## PCI-SIG ENGINEERING CHANGE NOTICE

<b>TITLE:</b>	FC Init
<b>DATE:</b>	Dec 11, 2003; Updated 26 Mar 2004
<b>AFFECTED DOCUMENT:</b>	PCI Express Base Specification Revision 1.0a
<b>SPONSOR:</b>	David Harriman, Intel Corporation

This ECR proposes modifications to the FC init protocol sections of the Base Specification that clarify the requirements regarding the permitted intervals and interruptions related to the protocol.

Figure 3-3: Flowchart Diagram of Flow Control Initialization Protocol

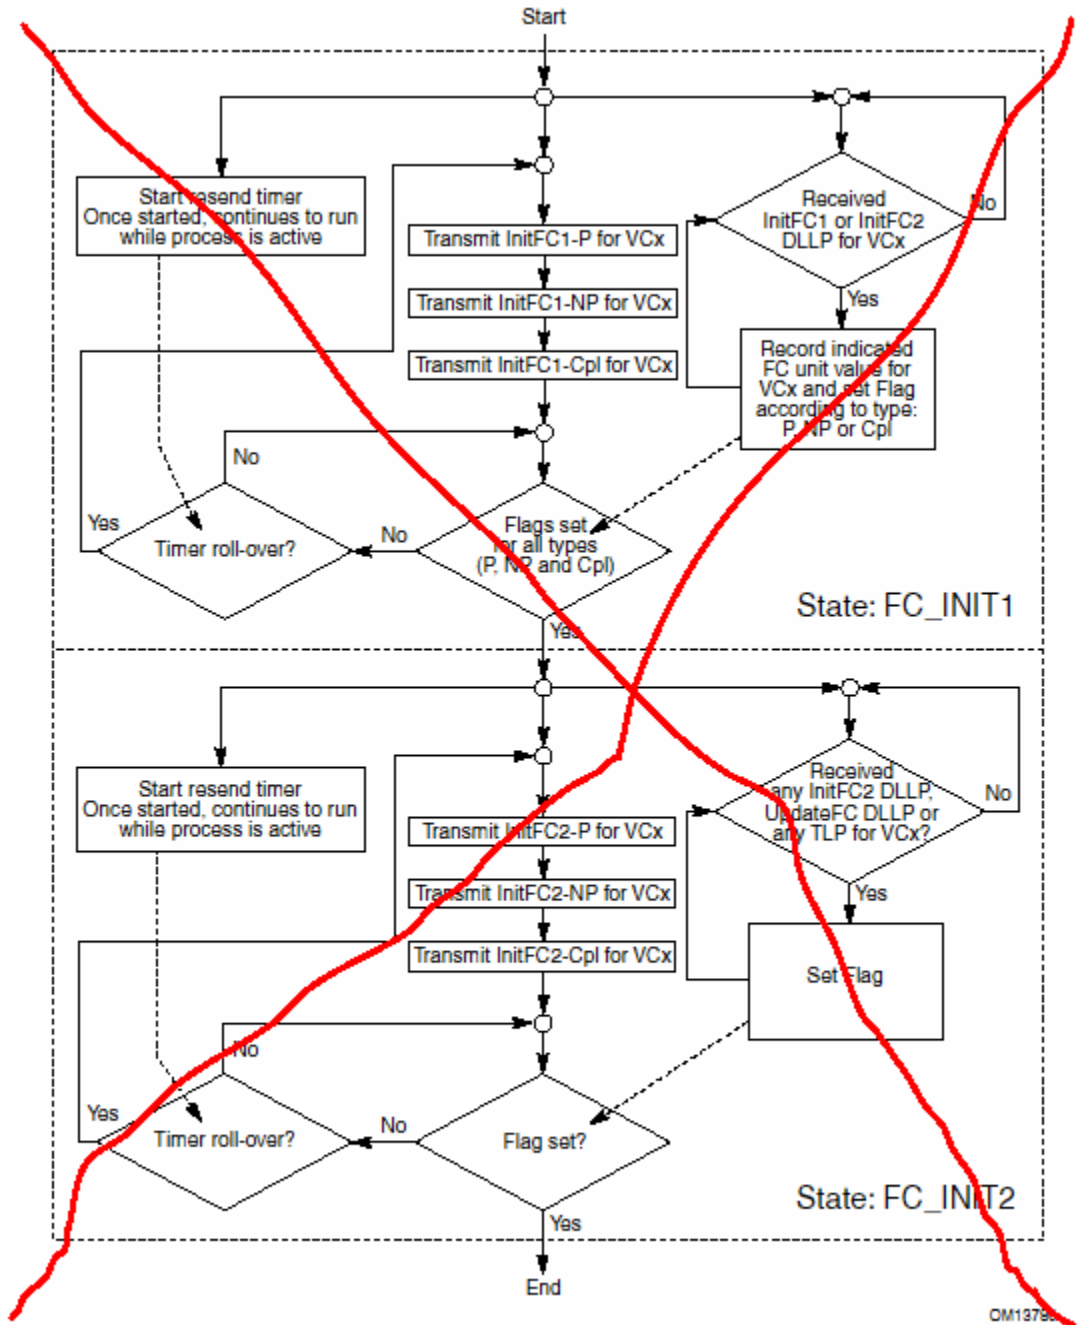
In 3.3 Flow Control Initialization Protocol, edit text & delete Figure 3-3:

The rules for this process are given in the following section. ~~Figure 3-3 shows a flowchart of the process.~~
